RADIO SERVICE DEPARTMENT

SPECIAL SERVICE BULLETIN FOR EDISON RADIO SERVICE ENGINEERS

SUBJECT: "Elimination or the reduction of hum level in JR and JC chassis."

SUBJECT: "Proposed factory changes in chassis design affecting  
JR and JC Models".

ELIMINATION OF HUM  
TO ACCOMPANY  
SERVICE BULLETIN #1

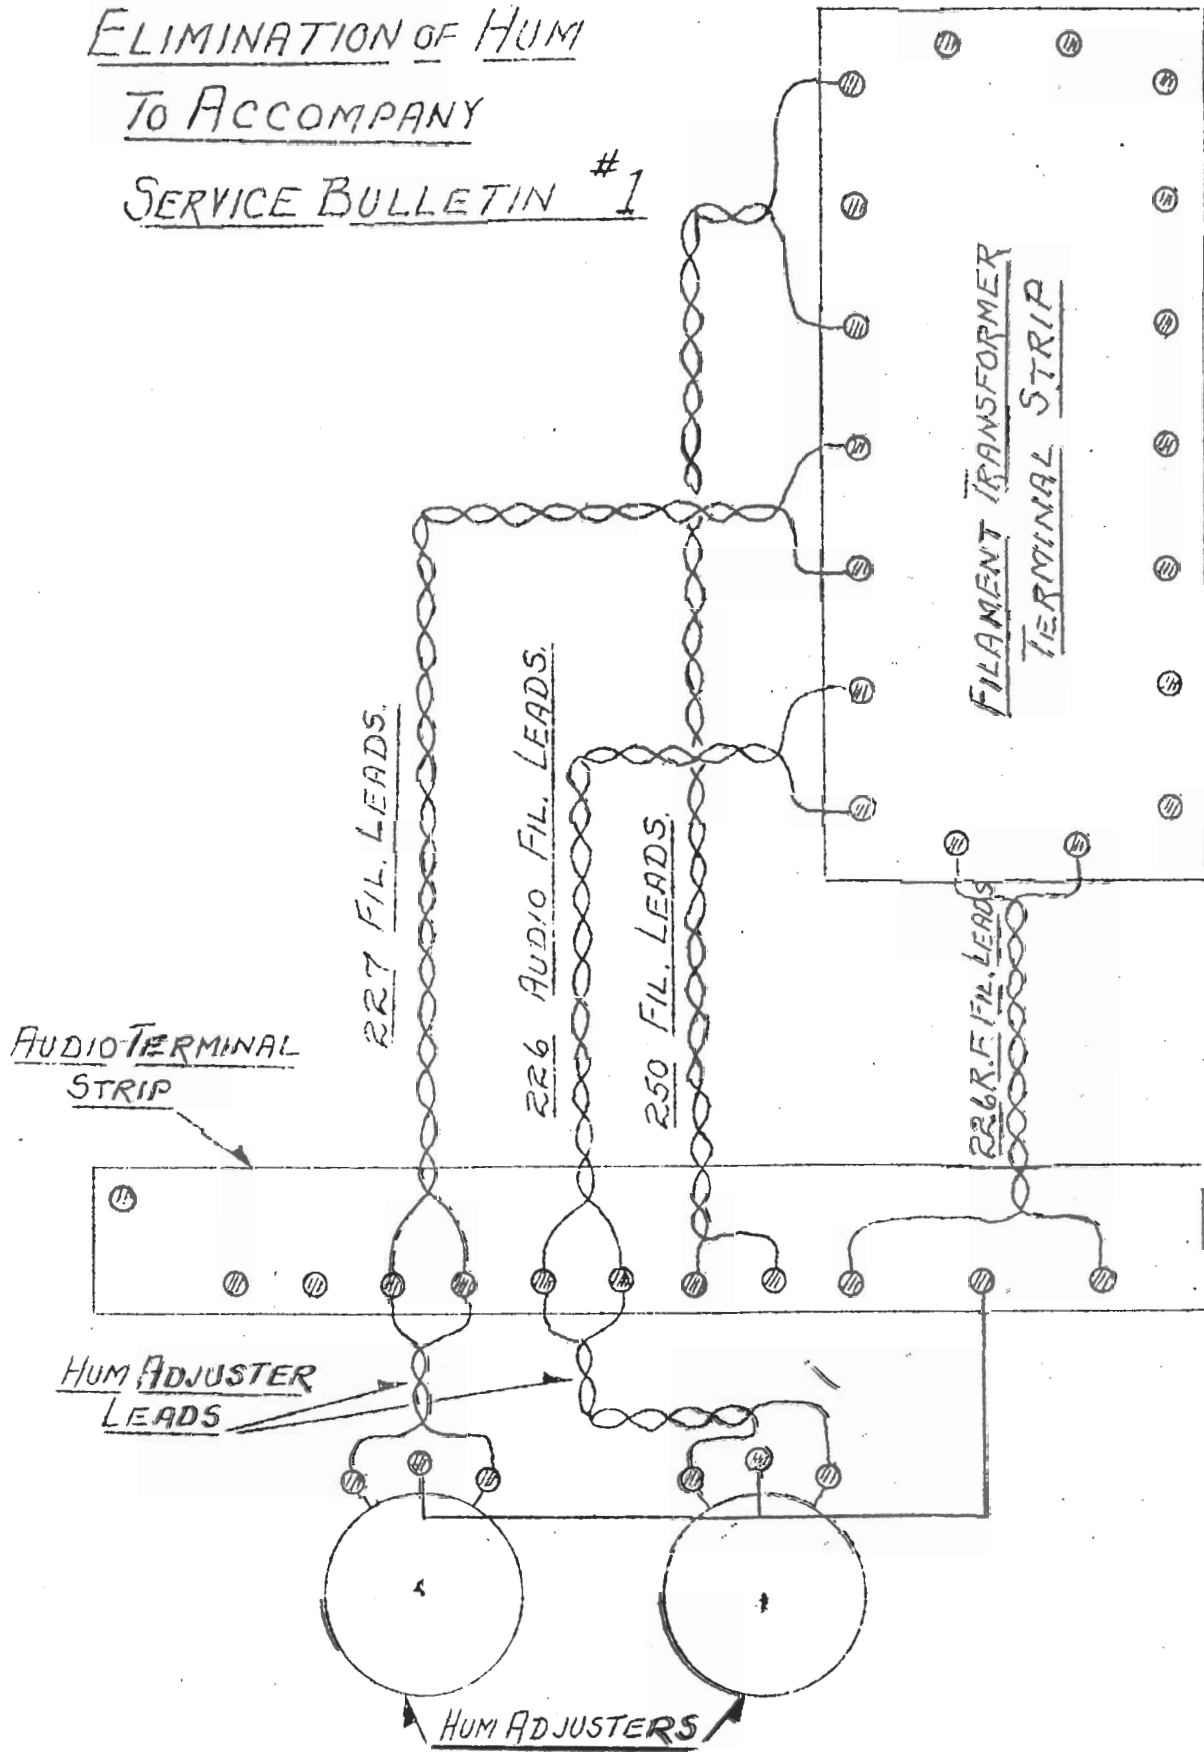
1. Remove power pack unit from chassis.
2. Reverse the secondary leads on the plate (power) transformer. With the power pack in it's normal position you will find these leads at the lower, bottom end of terminal board. The terminal lug at extreme bottom has attached to it two leads, one green covered wire and a yellow wire with red tracer, remove both of these leads and place them on the terminal just above and next to lowest terminal. Of course, placing the lead from second terminal on lowest terminal.

3. Remove the five bolts securing the filter condenser to power pack frame, permitting access and removal of all A.C. leads.
4. The filament leads to the 281 rectifier tube must be removed from cable and twisted together, then replaced in former position, back of filter condenser position.

5. Twist the 110 volt A. C. feeders, which connect the plug and line switch panel to primaries of power transformers. To do this, of course all cable lacing must first be removed from wires. After the twisting operation it will be unnecessary to replace lacing.

6. Braid the three leads which run from line switch points to primary terminals of Plate transformer.
7. Replace the Power pack unit, bolting to chassis frame.

8. It is advisable, because of color code used in cable from audio unit to power pack unit, to replace all these cable leads. Then, removing the R.F. (red) 226 filament leads, that is, unsolder them at transformer terminal block, pull them back along cable route, twist them and replace in regular position, soldering them to same terminals on transformer terminal block.

9. In the same manner twist the 227 detector filament leads.
10. In the same manner twist the 226 audio filament leads.

11. Remove the hum adjuster leads at the audio terminal strip. Twist these leads for each adjuster and resolder ends to terminal board.

12. Unsolder the pilot light leads at the pilot light. Pull the leads through condenser platform. Twist these leads and pull through platform hole and resolder to pilot light terminals.

Hooking up chassis and adjusting hum adjusters for minimum hum should reveal marked improvement in the elimination of "hum".

CONNECTIONS FOR EXTERNAL AND SEPARATELY EXCITED DYNAMIC SPEAKER

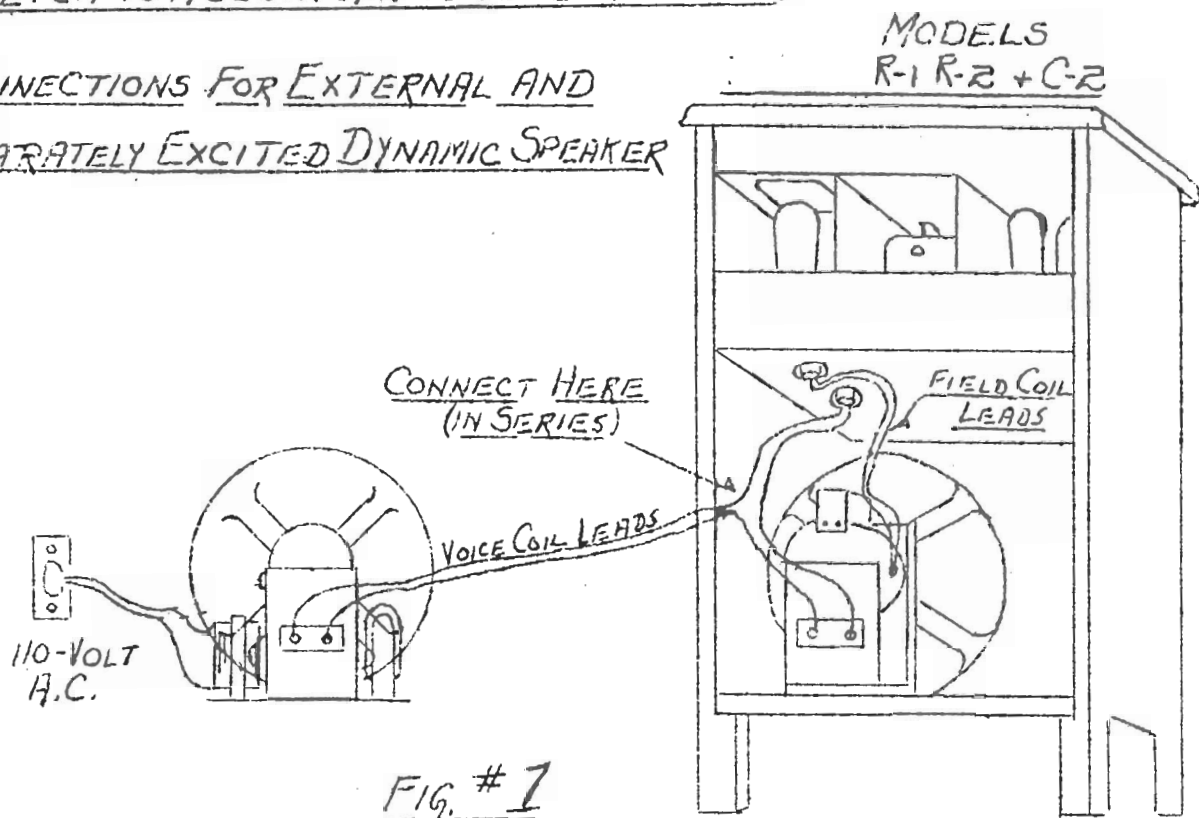
1. Connect voice coils in series.
2. External or additional speaker must be separately excited, that is the field of the external speaker must be excited direct from power line and must not be hooked up in connection with speaker field in set.
3. Approximately five percent loss of volume may result with this duplex speaker arrangement.
4. Such an installation has been arranged satisfactorily by an Orange dealer and is employed in a local hotel where the use of an additional speaker is desired, in a room removed from the set itself, and at an approximate distance of seventy-five feet. In this particular instance a Fada Dynamic Speaker was employed with excellent results.
5. This case is merely cited for your information and guidance in the event you are faced with similar problems in the field.

SKETCH SHOWS CAUSE FOR LOSS OF VOLUME IN PICK-UP.

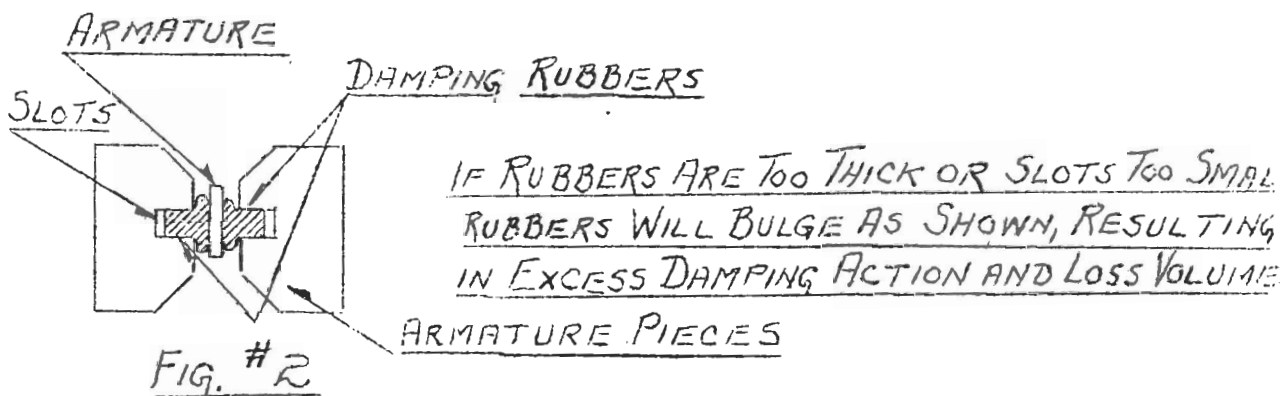
(a) Excessive damping, the pole piece slots may be too small or too narrow, resulting in improper damping action or prevention of proper damping adjustment by means of the adjustment provided for this purpose. That is, damping may be increased to an excessive amount but decreased damping will not result from change in adjustments provided, the narrowed slots in pole pieces preventing damping rubber from returning or resuming its natural position in slotted recess. To correct this condition in an emergency it is recommended that pole pieces be removed and the slots widened by filing. However, great care must be exercised in this operation, using a platinum file, trying the damping rubber frequently to insure a "snug" fit.

(b) Excessive damping and subsequent loss of volume may also result from damping rubber which may be too thick. The result being the same as in (a). The remedy, likewise being the same as in (a).

NOTE - TO CORRECT THIS CONDITION WIDEN SLOTS BY FILING SIDE WALLS, USING PLATINUM FILE OR EXTRA FINE FILE PERMITTING FREE MOVEMENT IN AND OUT OF DAMPING RUBBERS.

TO ACCOMPANY BULLETIN #9  
LOCATION OF DETECTOR SHIELD

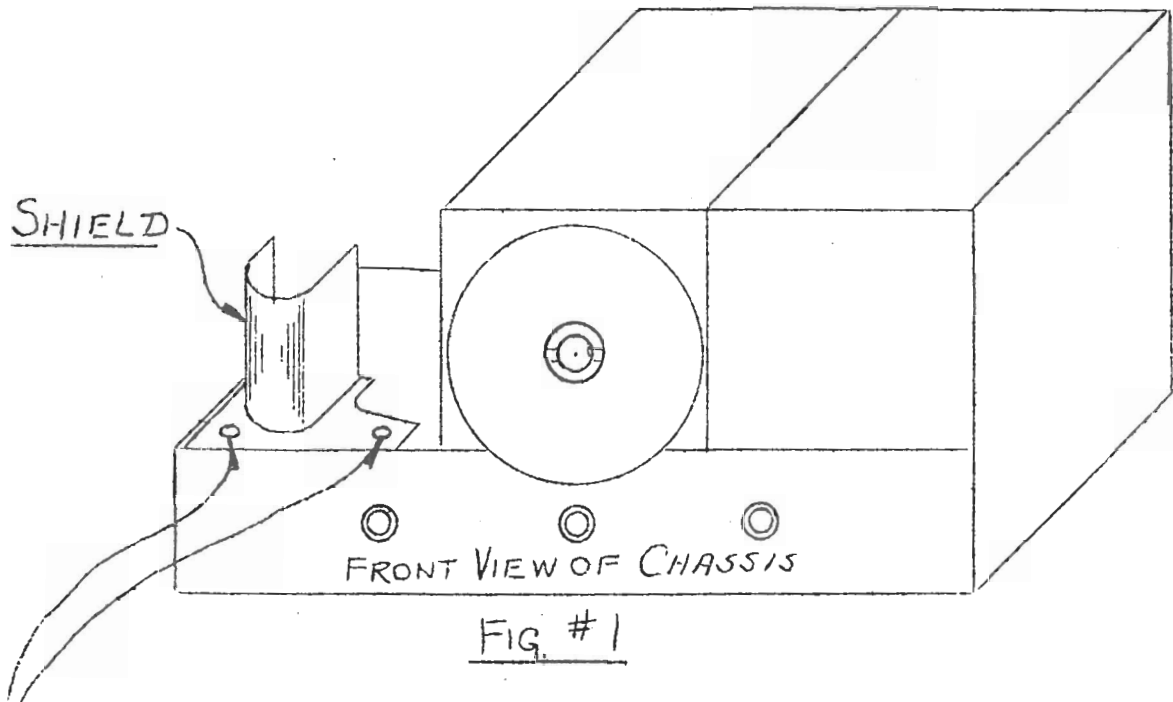
1. The laboratory has provided a limited number of special detector shields, made from copper, with insulated mounting base, to be attached to front end of tube mounting panel.

2. With the shield in position, secured by the panel holding screws, the detector tube is visible from the rear of cabinet.

3. The presence of this copper shield grounded to chassis frame, through panel holding screws, eliminates the microphonic effect, body capacity and all of the hum which accompanies the use of a so-called poor detector tube.

REMOVE TUBE SHELF SCREWS, PLACE SHIELD IN POSITION INDICATED AND REPLACE SCREWS THUS SECURING AND GROUNDING SHIELD TO CHASSIS FRAME.

NOTE, - MAKE SURE FIBRE INSULATING PLATE (SPACER) IS ATTACHED TO BASE OF SHIELD TO PREVENT SHORTING OF TUBE PRONG EYELETS.

# VIEW OF DYNAMIC SPEAKER

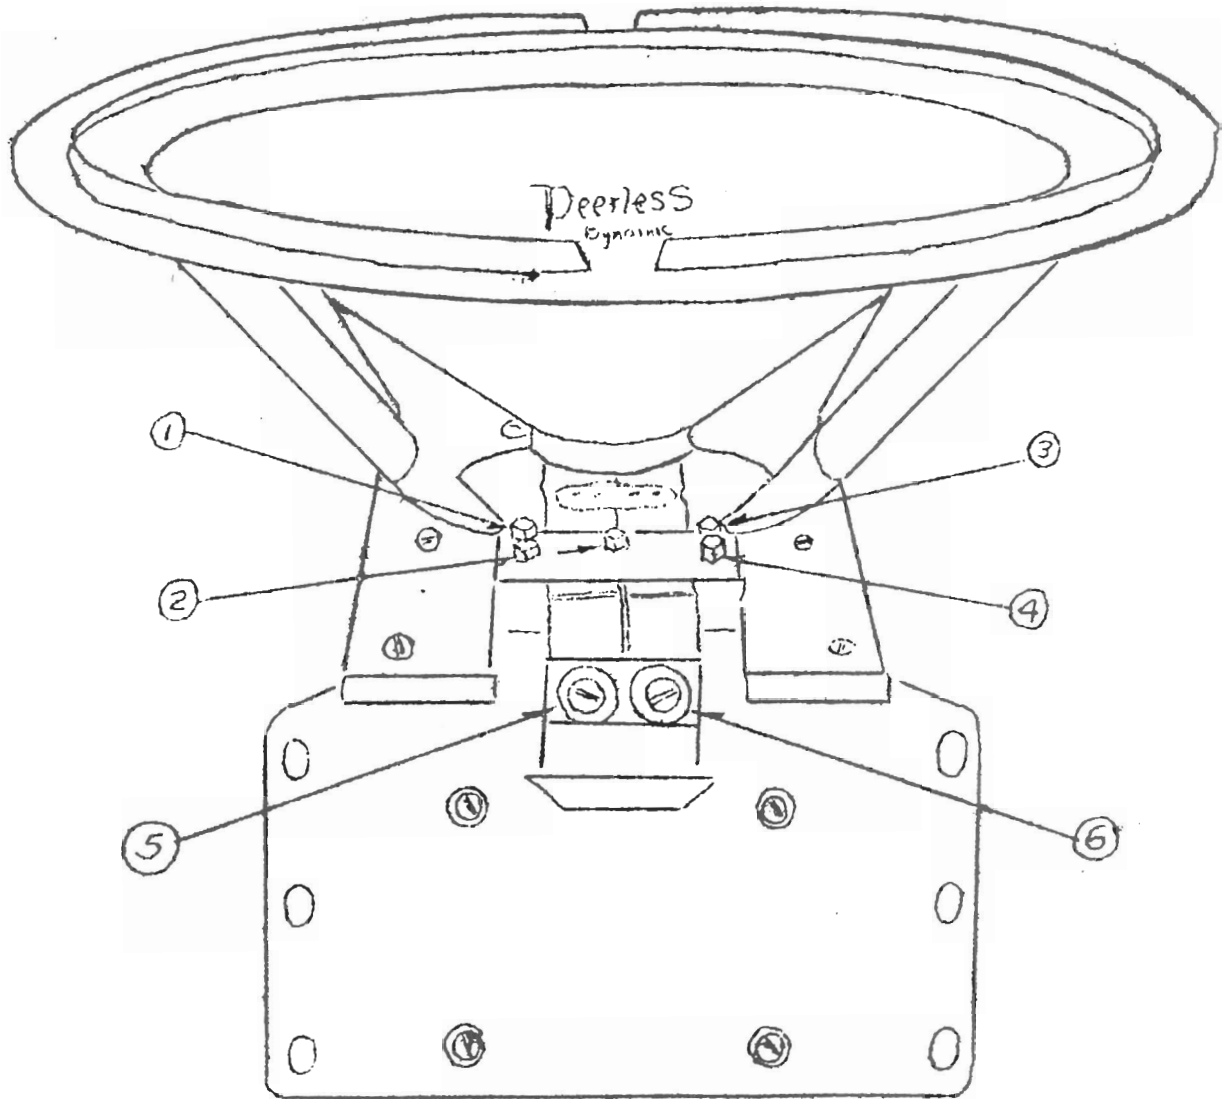
One of our field Service Engineers has been consistantly reporting that he finds speaker bolts very loose. In order to get the best volume and reproduction the following bolts must be drawn up tight.

1. Voice coil holding bolts numbered 1,2,3 and 4 on attached diagram.

2. Voice coil contact bolts numbered 5 and 6 on same diagram.

① VOICE COIL HOLDING BOLTS... ③

② " " " " ④

⑤ THESE CONTACT BOLTS MUST BE TIGHT

⑥ " " " " " "

FIGURE 1.

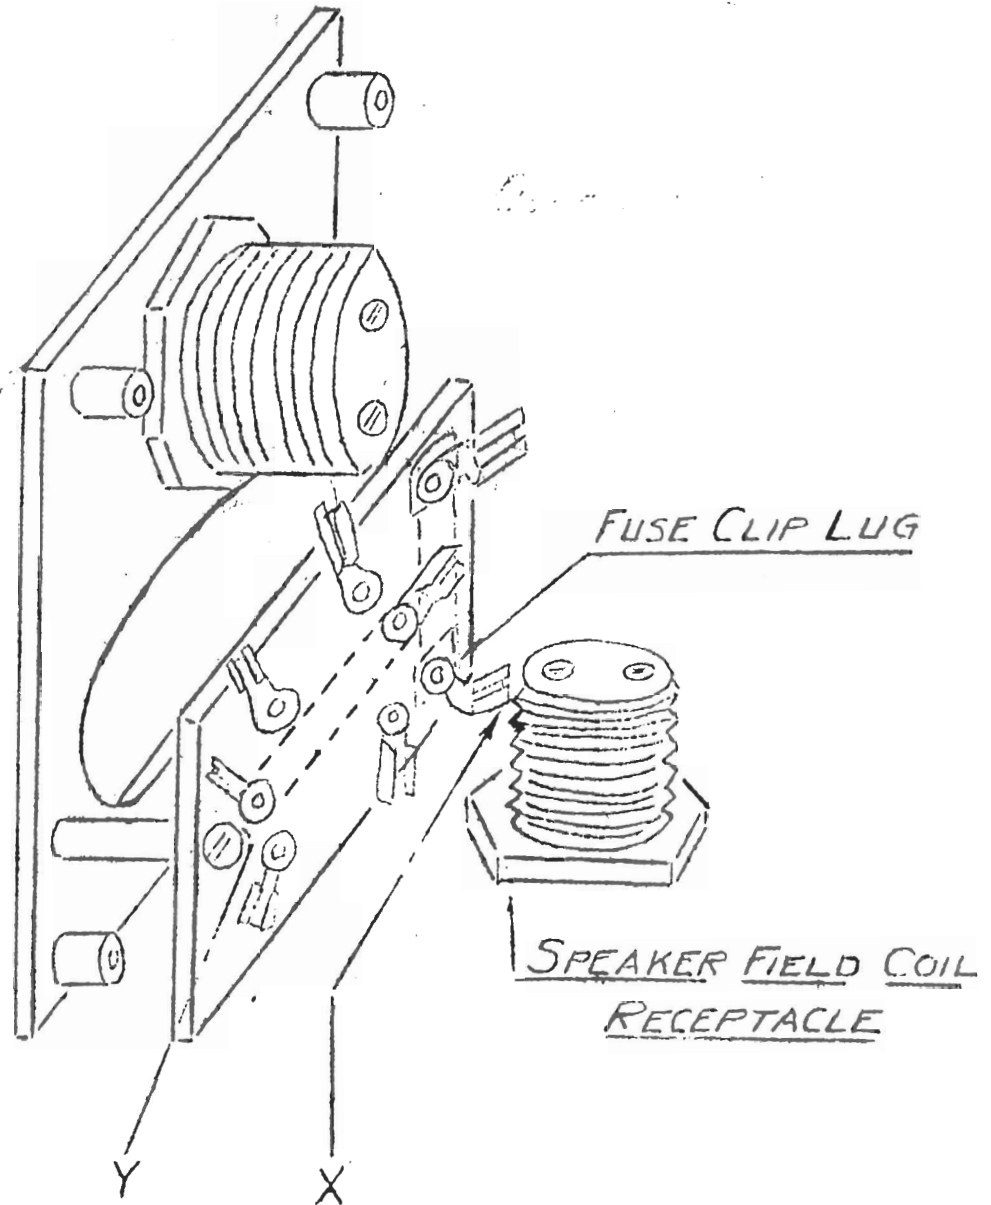
2. The Attached figure indicates the location of possible short in chassis which will result in burned out primary IF THE GROUND WIRE IS ATTACHED TO ANTENNA POST OR IF ANTENNA ITSELF BECOMES GROUNDED.

3. To eliminate possibility of such ground-push connecting lugs as far away as possible from field coil plug shell, at X and from screw head, at Y. See figure 1.

FIG. 1

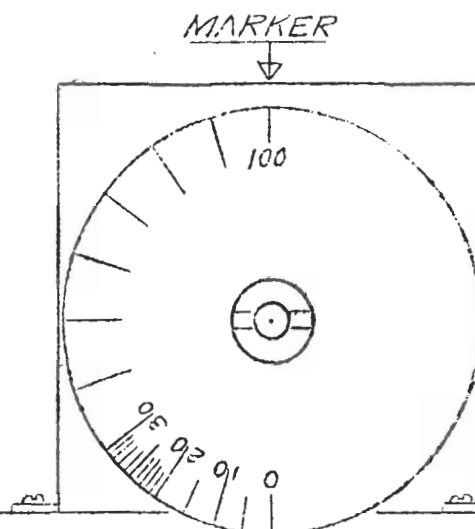
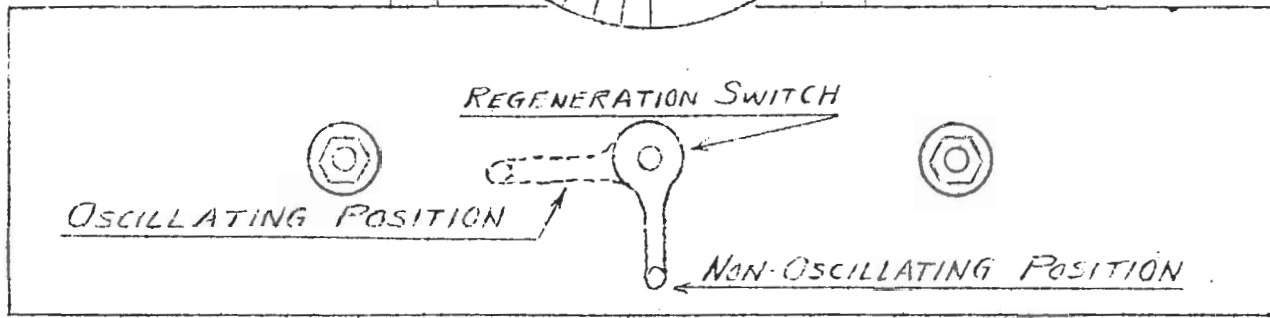
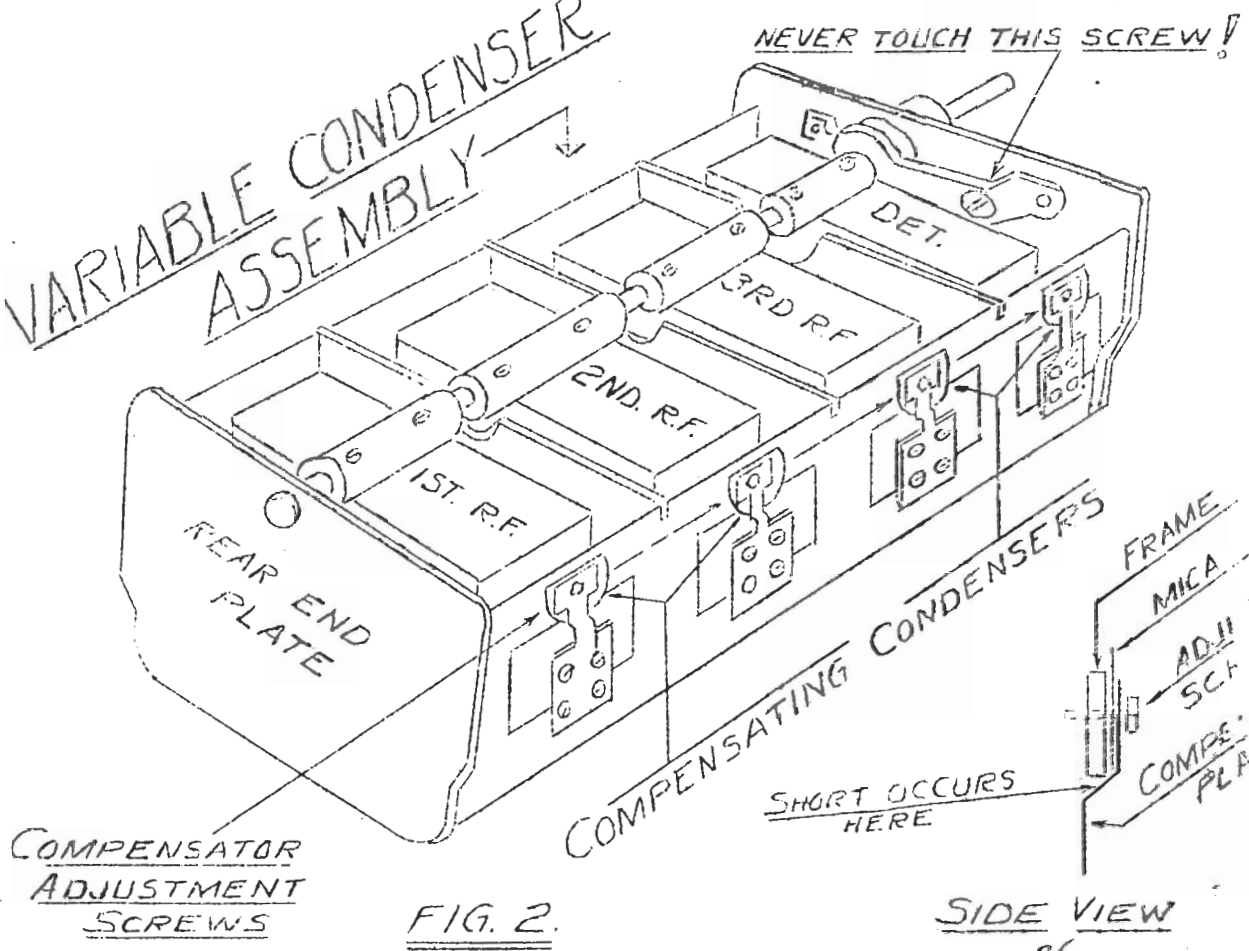
2. Rotate dial to 100 position, condenser plates should now be fully enmeshed. Fix dial marker, as in figure 1, marker indicating exactly 100 on dial.

3. A station should be selected between 20 and 30 on the dial. If the station you select is broadcasting on a wave length of 260 meters, then set your dial exactly at 25. Leave dial in this position until tuning adjustments are complete. Any other station between these points may of course be selected.

4. Move regeneration Switch to Regenerative Position. With volume control turned up as much as possible but always just below the "spilling point", use balancing tool, turning the detector compensator adjustment screw, all the way in or out to locate the point of maximum volume. As the balancing tool is removed from adjustment screw a slight decrease in volume may be noticed. If so, set up or tighten the adjustment screw a trifle until maximum volume results with balancing tool removed. This condition will hold, probably with the remaining adjustment screws.

5. Do not change dial setting. Next and in a similar manner adjust the (adjoining) third R. F. compensating condenser - FOR MAXIMUM VOLUME.

6. Likewise adjust the second and first R.F. compensating condensers - FOR MAXIMUM VOLUME.

7. It is usually well to check the detector compensator setting as a final adjustment.

8. Now tune in a high wave station between 75 and 85 on the dial, and once more go through the procedure as outlined in preceding paragraphs 4,5,6, and 7. If you find only slight changes are necessary in compensator adjustments, set compensator adjusting screws half way between their settings for low wave and high wave. If, however, you find that it is impossible to get a point of maximum volume on one or more compensators when adjusting on a high or low wave signal, it is advisable to replace the gang condenser.

ROTATE CONDENSERS TO POSITION OF MAXIMUM CAPACITY. PLATES FULLY ENMESHED. SET MARKER DIRECTLY ABOVE 100.  
MAKE SURE POSITION OF MARKER REMAINS FIXED  
ROTATE DIAL TO A STATION - PREFERABLY BETWEEN 20 AND 30.  
PLACE SWITCH IN REG. POSITION - INCREASE VOLUME TO "NEAR REG." THEN ADJUST EACH COMPENSATOR FOR MAXIMUM VOLUME.
